CALL NO. 408  
CONTRACT ID NO. 252198  
ADDENDUM # 1

Subject: Kenton-Boone Counties, 121GR25P048 - FD05, FE01, & FD04  
Letting May 22, 2025

- (1) Revised - Notes - Pages 43, 44 & 46 of 165
- (2) Revised - Material Summary - Pages 89-94 of 165
- (3) Revised - Proposal Bid Items - Pages 162-165 of 165

BOONE CO. US 25 ~m.p. 11.31  
~LAT/LONG N 39.00539, W 84.61716  
STATION G39

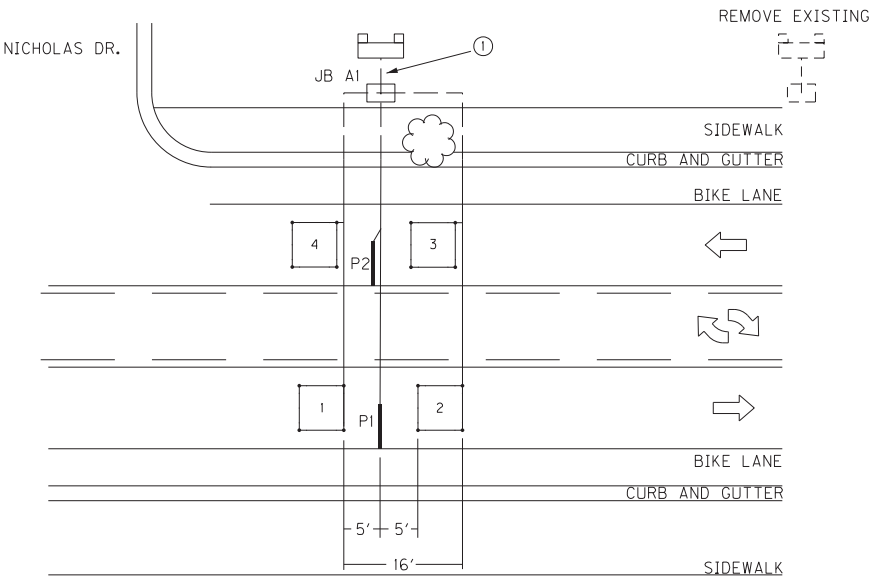
ALL LOOPS SHALL BE 6'X6' SQUARE AND SHALL BE INSTALLED 16' FROM LEADING EDGE TO LEADING EDGE AS SHOWN. PIEZOELECTRIC SENSORS (PIEZOS) SHALL BE INSTALLED 5' FROM THE EDGE OF LOOPS WITH THE EDGE OF EACH PIEZO FLUSH WITH THE EDGE OF THE CORRESPONDING DRIVING LANE. LOOPS AND PIEZOS SHALL BE INSTALLED SPLICE-FREE TO THE CABINET AND A MINIMUM OF 2' OF WIRE FOR EACH SENSOR SHALL BE COILED INSIDE EACH JUNCTION BOX AND CABINET. ALL LOOPS AND PIEZOS SHALL BE LABELED IN ALL JUNCTION BOXES AND CABINET. DIVISION OF PLANNING PERSONNEL WILL CONNECT THE LOOPS AND PIEZOS INSIDE THE CABINET.

REMOVE AND REPLACE THREE (3) NARROW SECTIONS OF SIDEWALK TO ROUTE CONDUIT TO TYPE A JUNCTION BOX.

INSTALL ONE (1) 1 1/4" CONDUIT FROM EACH SAW SLOT TO NEAREST JUNCTION BOX.

INSTALL ONE (1) TYPE A JUNCTION BOX (JB A1).

INSTALL ONE (1) 20"X20"X8" CABINET MOUNTED TO TWO (2) WOOD POSTS.

TRANSFER WIRING HARNESSES AND TERMINAL STRIPS FROM OLD CABINET TO THE NEW ONE AND REMOVE EX. CABINET, WIRE, CONDUIT, POST AND DISPOSE OF OFF THE PROJECT.

- ① INSTALL ONE (1) 2" CONDUIT.

KENTON CO. US 25 m.p. 5.88  
~LAT/LONG N 39.01480, W 84.60402  
STATION G42

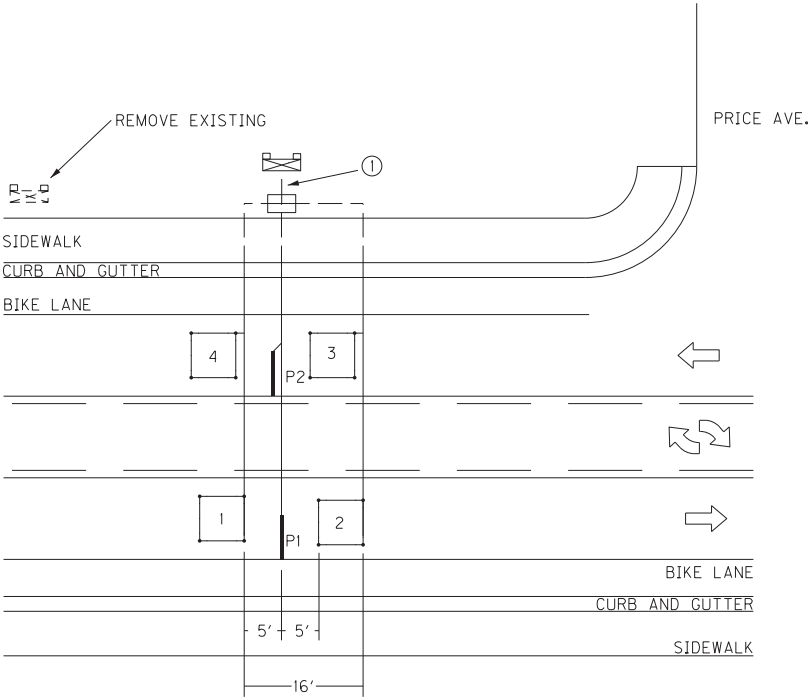
ALL LOOPS SHALL BE 6'X6' SQUARE AND SHALL BE INSTALLED 16' FROM LEADING EDGE TO LEADING EDGE AS SHOWN. PIEZOELECTRIC SENSORS (PIEZOS) SHALL BE INSTALLED 5' FROM THE EDGE OF LOOPS WITH THE EDGE OF EACH PIEZO FLUSH WITH THE EDGE OF THE CORRESPONDING DRIVING LANE. LOOPS AND PIEZOS SHALL BE INSTALLED SPLICE-FREE TO THE CABINET. A MINIMUM OF 2' OF WIRE FOR EACH SENSOR SHALL BE COILED INSIDE EACH JUNCTION BOX AND A MINIMUM OF 4' OF WIRE FOR EACH SENSOR SHALL BE COILED INSIDE THE CABINET. ALL LOOPS AND PIEZOS SHALL BE LABELED IN ALL JUNCTION BOXES AND CABINET. DIVISION OF PLANNING PERSONNEL WILL CONNECT THE LOOPS AND PIEZOS INSIDE THE CABINET.

REMOVE AND REPLACE THREE (3) SLENDER SECTIONS OF SIDEWALK (AVOIDING DECORATIVE BRICK) TO INSTALL 1 1/4" CONDUIT TO THE TYPE A JUNCTION BOX.

INSTALL ONE (1) 1 1/4" CONDUIT FROM EACH SAW SLOT TO NEAREST JUNCTION BOX.

INSTALL ONE (1) TYPE A JUNCTION BOX (JB A1).

INSTALL ONE (1) 20"x20"x8" GALVANIZED STEEL CABINET ON TWO (2) WOOD POSTS.

TRANSFER WIRING HARNESSES AND TERMINAL STRIPS FROM OLD CABINET TO THE NEW ONE AND REMOVE THE OLD EXISTING EQUIPMENT AND DISPOSE OF OFF THE PROJECT.

① INSTALL ONE (1) 2" CONDUIT.

BOONE CO. US 42 ~m.p. 14.26  
~LAT/LONG N 38.98834, W 84.63895  
STATION K46 EB

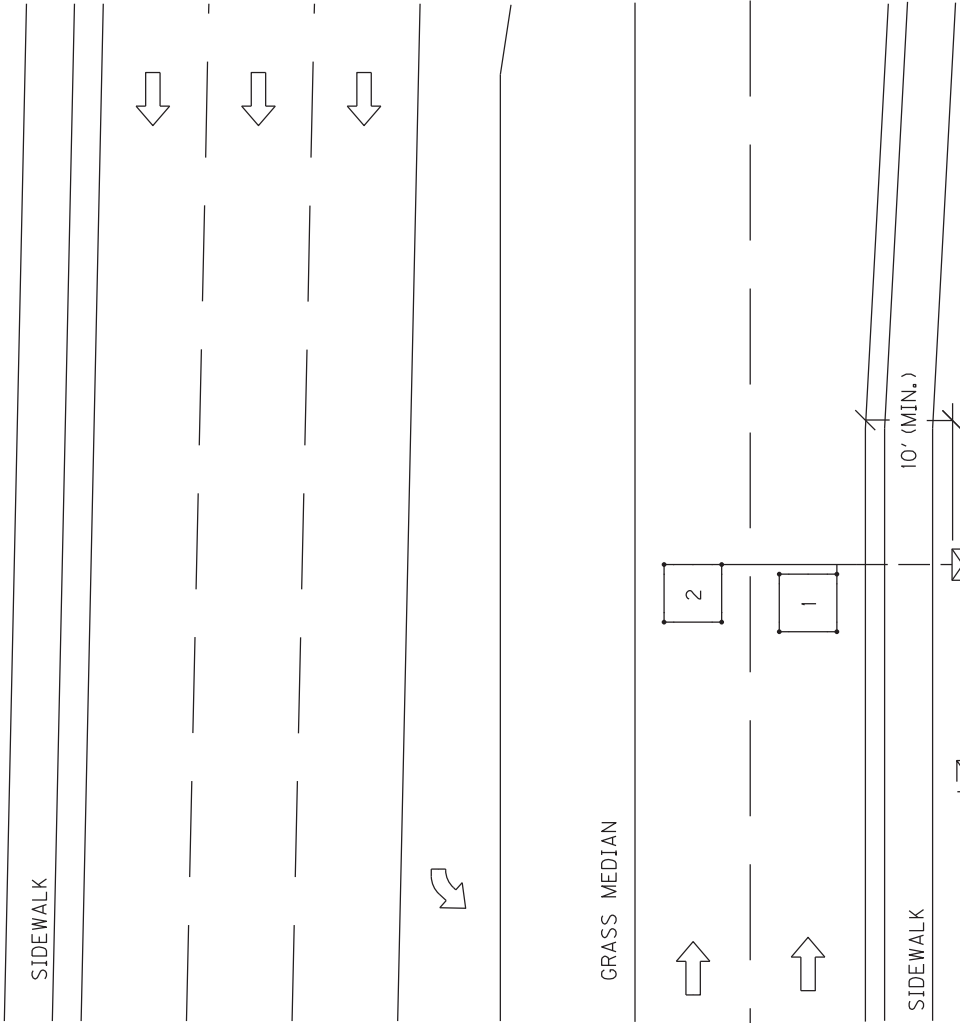
ALL LOOPS SHALL BE 6'X6' SQUARE. LOOPS SHALL BE INSTALLED SPLICE-FREE TO THE CABINET AND A MINIMUM OF 2' OF WIRE FOR EACH SENSOR SHALL BE COILED AND LABELED INSIDE THE CABINET. DIVISION OF PLANNING PERSONNEL WILL CONNECT THE LOOPS INSIDE THE CABINET.

INSTALL ONE (1) 10"x8"x4" CABINET MOUNTED TO ONE (1) WOOD POST.

INSTALL ONE (1) 1 1/4" CONDUIT FROM SAW SLOT TO 10"x8"x4" CABINET.

REMOVE AND REPLACE ONE (1) SECTION OF SIDEWALK TO INSTALL CONDUIT FROM SAW SLOT TO THE CABINET.

REMOVE EX. 10'x8'x4' CABINET AND DISPOSE OF OFF THE PROJECT
